**GREENWAY TRAILS
PLANNED DEVELOPMENT NO. 63
BASE ZONING DISTRICT: MF-1 MULTIFAMILY
ORDINANCE NO. 22-12-15-41
(ADOPTED 12-15-2022)**

- **PDA23-0001: MINOR PD AMENDMENT FOR MINOR SITE DESIGN CHANGES (APPROVED BY STAFF 3-6-2023)**
- **PDA24-0008: MINOR PD AMENDMENT FOR SITE DESIGN CHANGES AND UPDATES TO DEVELOPMENT STANDARDS (APPROVED BY STAFF 8-22-2024)**

Minor PD, Planned Development Amendment Application*

To amend PDA23-0001 Minor PD, Planned Development Amendment as outlined below:

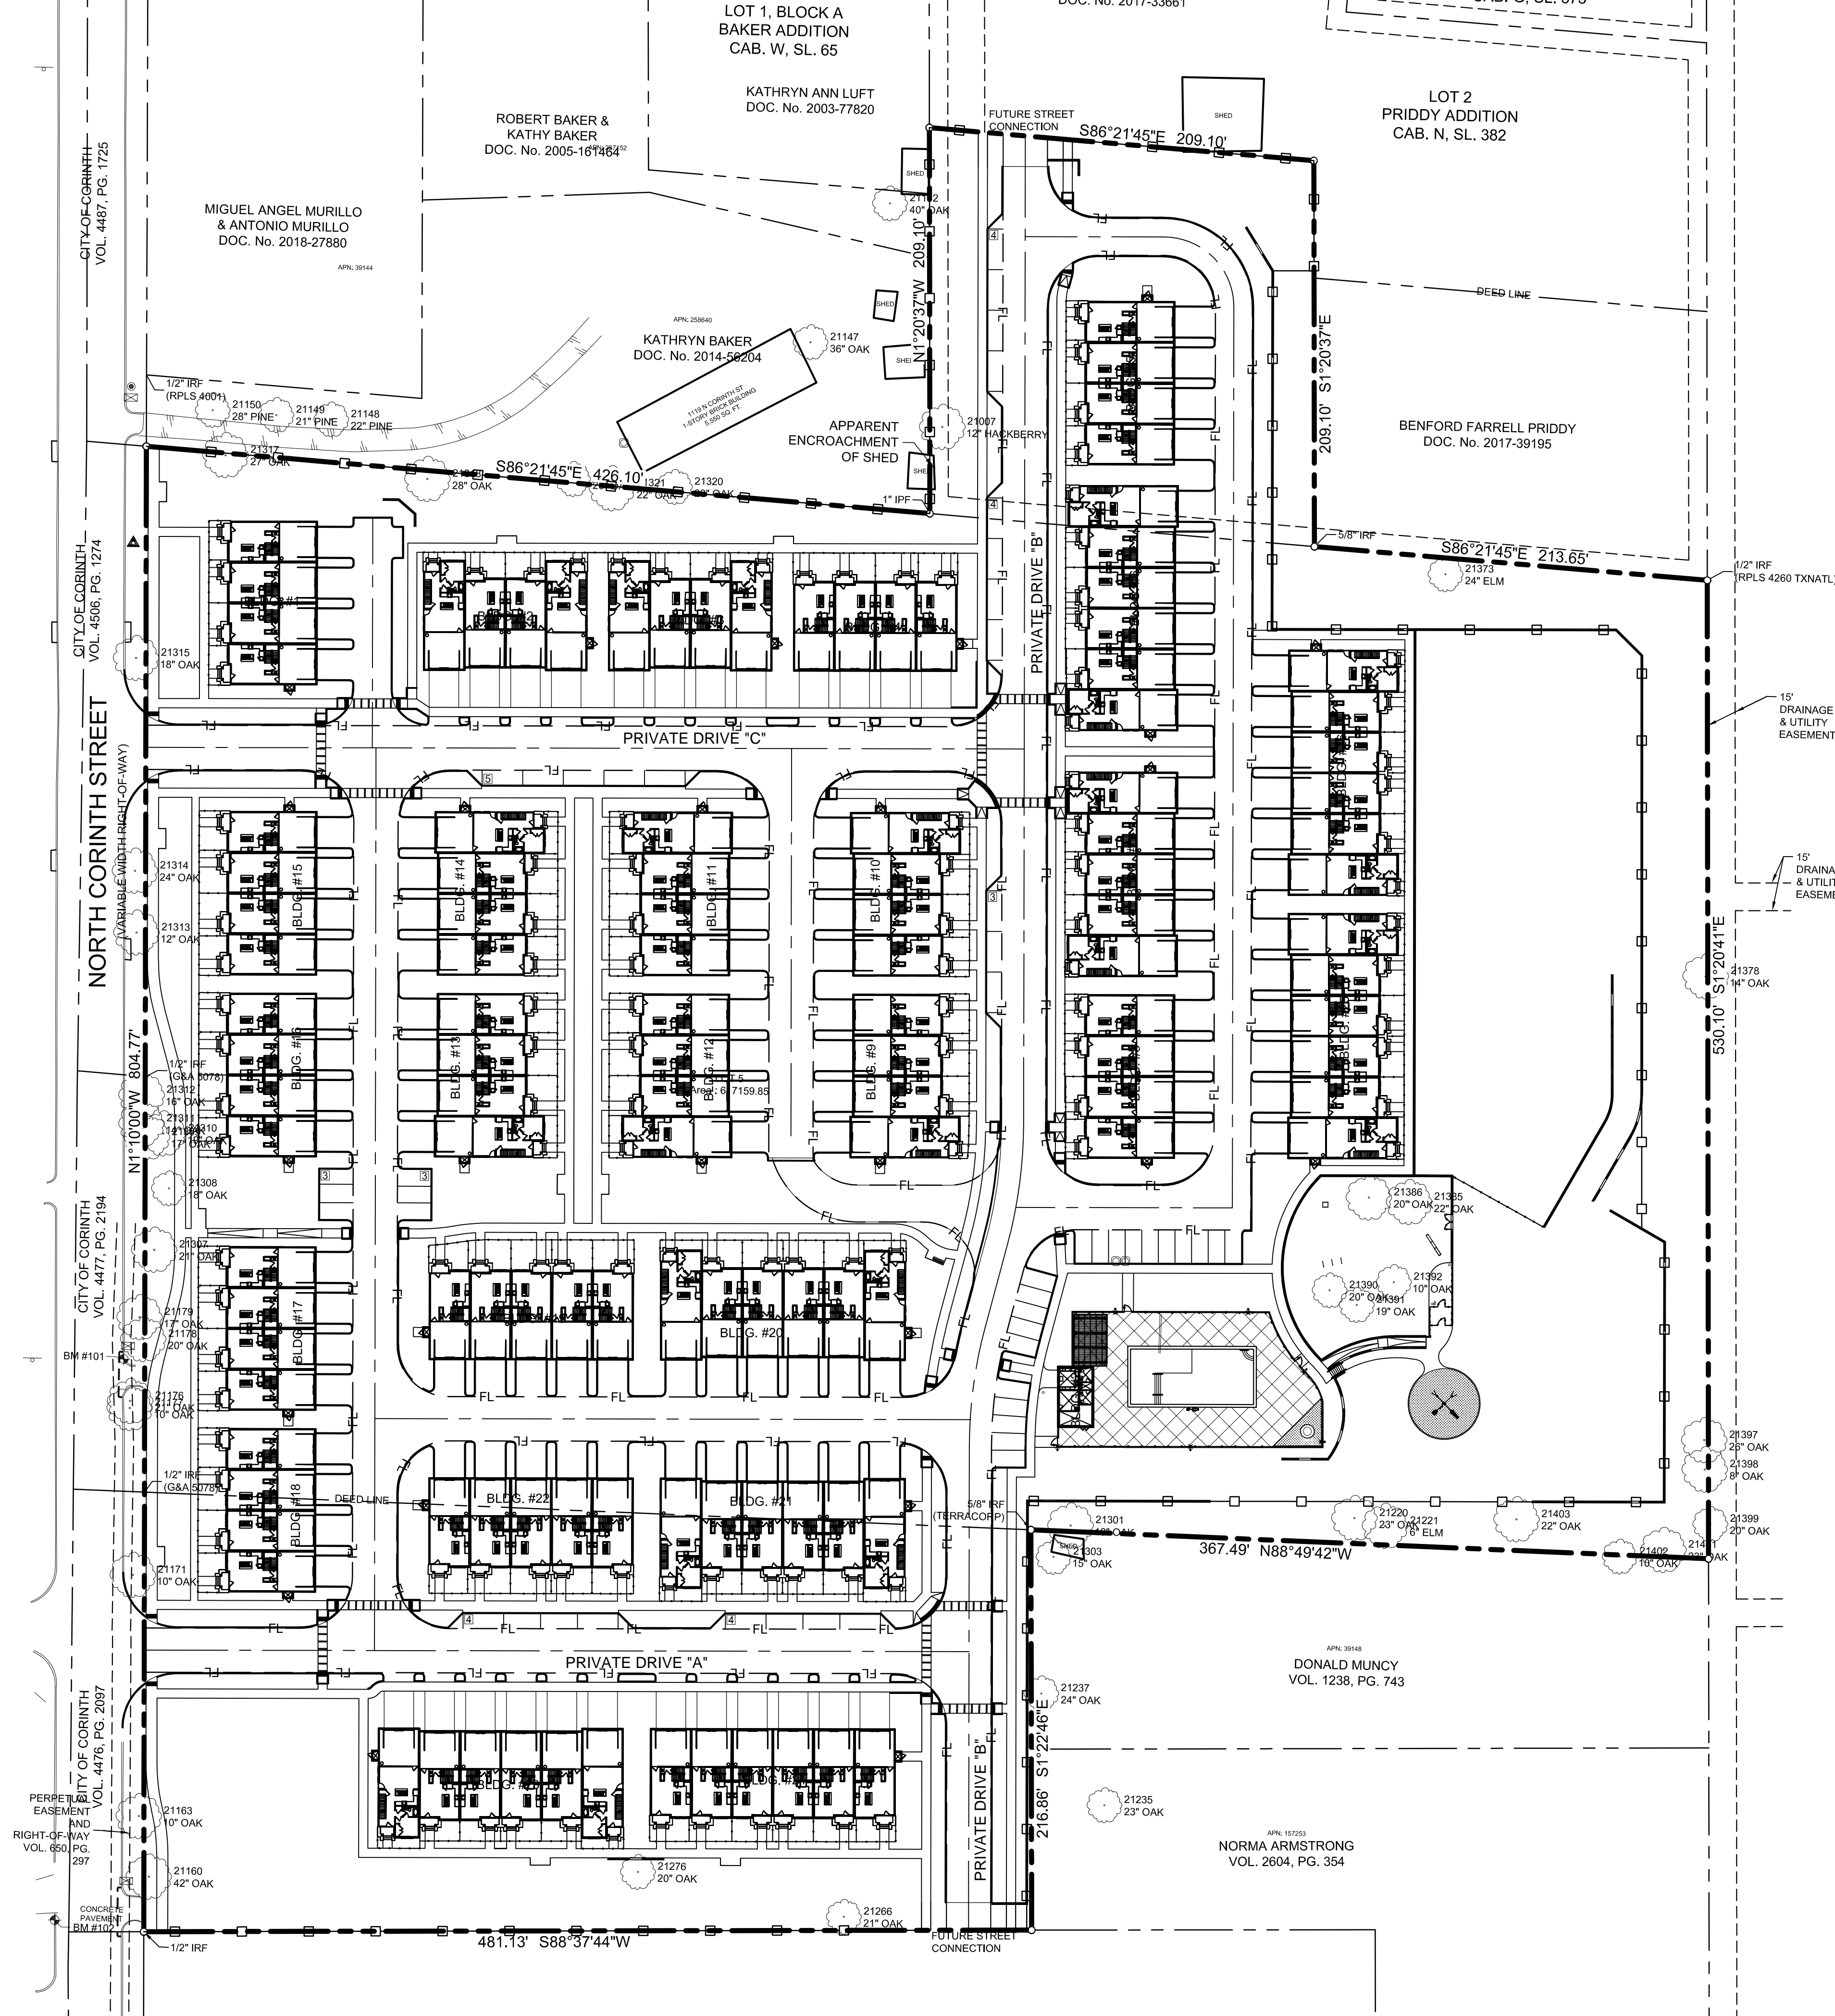
Request: To amend PD-63 to reflect the modifications made in the attached updated Exhibit "B" and "C" and as further outlined below:

- (4) Grading for drive connection at Southeast entrance of site revised to end 10’ from property line;
- (5) Fire lane South of buildings 25 and 26 revised to 20’;

- (6) Buildings 23 and 24 moved North to create buffer between the alley and Southern property line;
- (7) One unit added to building 23 (6 units total now);

- (10) Parking area within drive B shifted from right side to left side of drive;
- (11) Building 5 revised from 5 units to 6 units;
- (12) Removed drive between buildings 9 and 20 (mirrored buildings 11 and 12) and replaced with a 20’ grasscrete fire lane that connects to private drive B.

1. Amend line #1 to read as follows: Fire lane North and East of Buildings ~~4, 5, and 8~~ 5, 6, 7 & 8 reduced to 20';
2. Amend line #3 to read as follows: Space between buildings 5 and 6 reduced from 30' to 10';
3. Remove lines #2, 4, 5, and 6.
4. Amend line #9 to read as follows: One unit removed from buildings 12, 13, and 16 so site could be shifted further North to create buffer from Southern property line to ~~the alley of~~ buildings 23 and 24;
5. Amend line #11 to read as follows: Building ~~5~~ 6 revised from 5 units to 6 units;
6. Amend line #13 to read as follows: Reworked sidewalk along private drive B (between buildings ~~8 and 5~~ 7 and 6) to allow for landscaping.
7. Add new line item #14 to include: Head in parking added to the East side of drive B.

This Minor PDA shall supersede any conflicting standards approved and presented on "Exhibit B" – PD Concept Plan, "Exhibit C" – Concept Landscape and Screening Plan, and Exhibit "F" – Tree Survey and Preliminary Tree Preservation Plan in Planned Development Ordinance No. 63 (PD-63) as adopted on December 15, 2022.

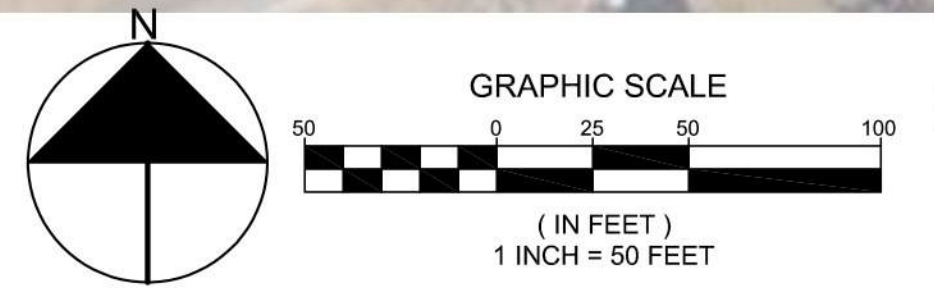
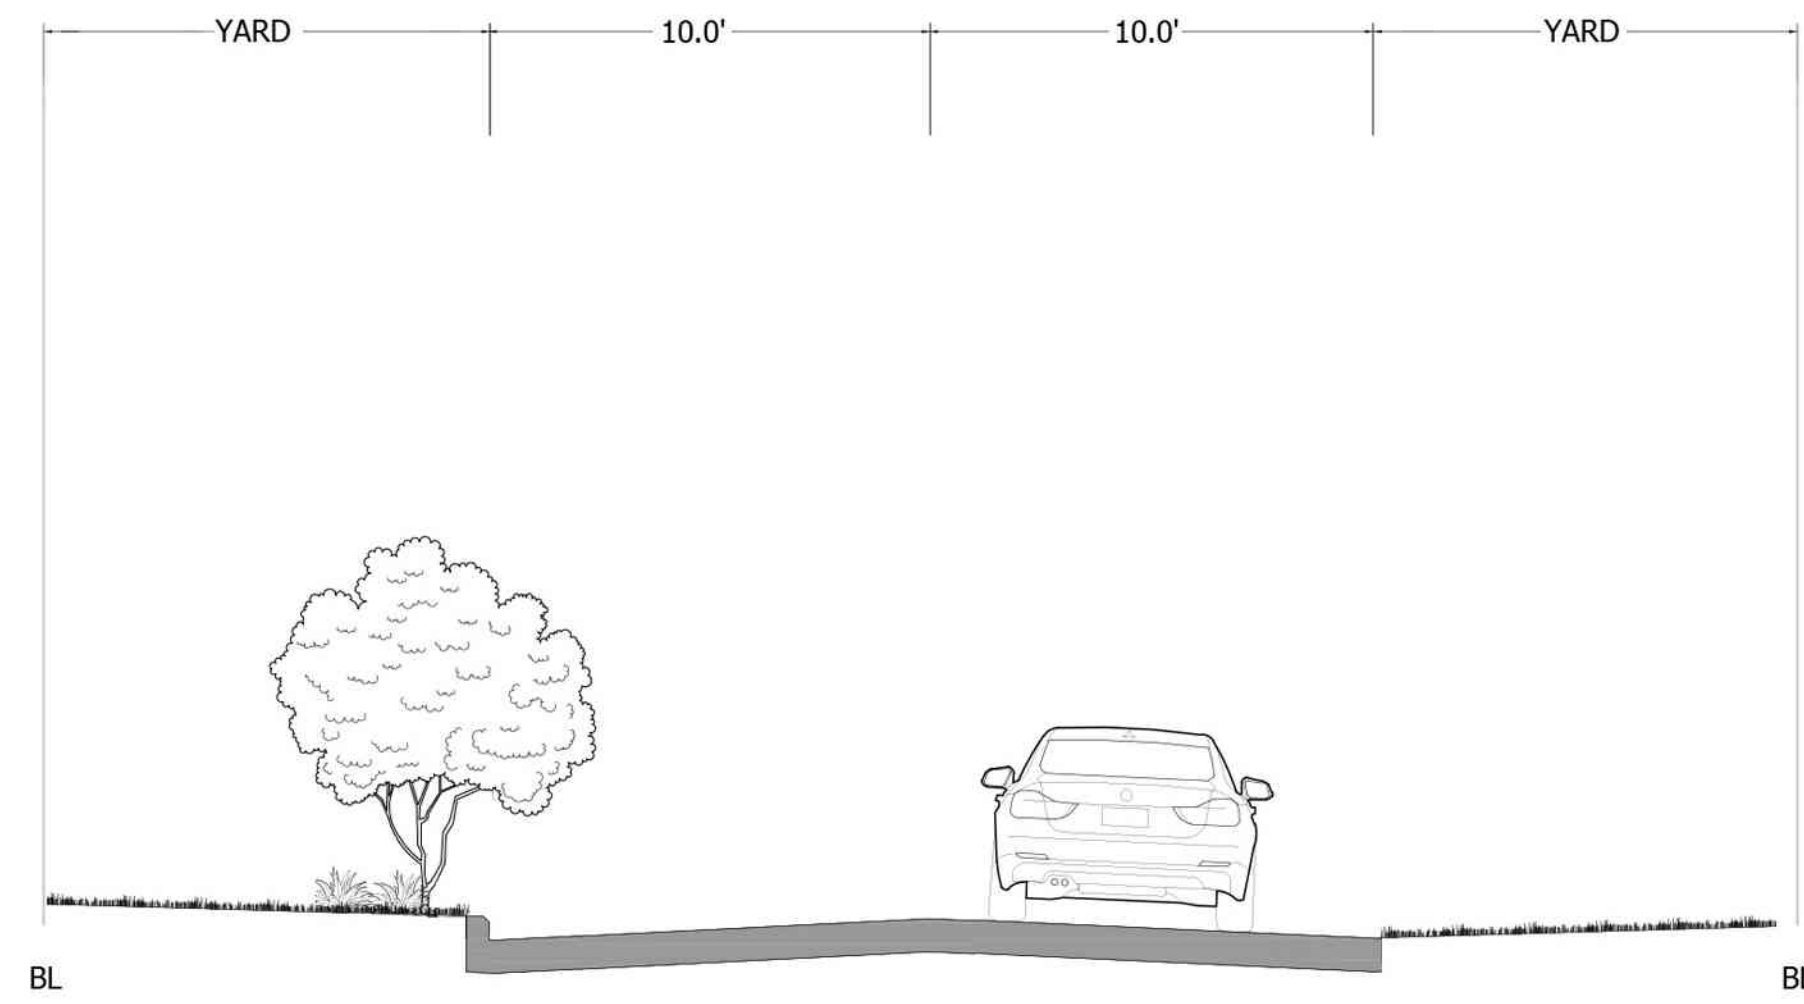
6. Amend Section 2.D.7.a to read as follows: Subsection 2.09.05.C.1.a. shall be modified to require more specific adjacency standards as follows: A six-foot (6') high ornamental metal fence is to be provided along the entirety of the northern boundary, except for the width of Private Drive "B" future street connection depicted on Exhibit "C." ~~Staggered~~ evergreen plant material consisting of Holly Trees or similar plant material to be planted at five feet (5') on center that will reach full opacity within two (2) years shall be included parallel to the ~~twelve-foot (12')~~ alley sidewalk adjacent to the northern boundary. Additional landscaping enhancements shall be provided in the northern open space west of Private Drive "B" and between the northern property boundary and the 24' fire lane, the sidewalk north of building ~~#26 and the detention pond #6 and detention pond No. 3~~ open space such as decorative shrubs, hedges, and ornamental trees. A six-foot (6') high ornamental metal fence is to be provided ~~along adjacent to~~ the entirety of the eastern boundary along retaining walls to function as screening and fall protection fencing with ~~staggered~~ evergreen plant material consisting of Holly Trees or similar plant material to be planted at five feet (5') on center that will reach full opacity within two (2) years. ~~Additional landscaping enhancements shall be provided between the eastern property boundary and east of Private Drive "E" and detention pond No. 3 open space such as decorative shrubs, hedges, and ornamental trees.~~ A six-foot (6') high ornamental metal fence shall be provided along the entirety of the southern boundary, except for the width of Private Drive "B" future street connection ~~and Private Drive "E" future street connection~~ depicted on Exhibit "C." Additional landscaping enhancements shall be provided between the southern property boundary and the ~~sidewalk twelve foot (12') alley~~, east of Private Drive "B" and the 24' fire lane such as shade trees, decorative shrubs, hedges, and ornamental trees.

7. Amend Section 2.D.11.b to read as follows: The Builder shall construct a dooryard with four-foot (4') high ornamental metal fence for buildings fronting onto N. Corinth Street and for buildings located throughout the development, with the possible exception of buildings ~~#25 & #26 #6 and #7~~ that will be further evaluated at time of Site Plan based on the future design of the detention basin. Additionally, landscaping and shrubs shall be planted directly in front of , or if space is not available behind, the dooryard fence for additional screening.

9. Amend Section 2.D.12.a to read as follows: Front yard standards shall be in conformance with the PD Concept Plan, Exhibit "B", providing a minimum of seven feet (7') between the front façade and the sidewalk, except that end units may be reduced to a minimum of five feet (5') in certain instances for building #23, three feet (3') for buildings #25 and #26, and one foot (1') for buildings #6 and #7 as depicted on Exhibits "B" and "C." Dooryards shall be permitted with ornamental fencing as generally represented on Exhibit "C." Further, the width of the mews, where provided, shall be in general conformance with the PD Concept Plan, Exhibit "B", with the recessed façade off-sets generally depicted on Exhibits "B" and "C" to ensure variety of the facades.
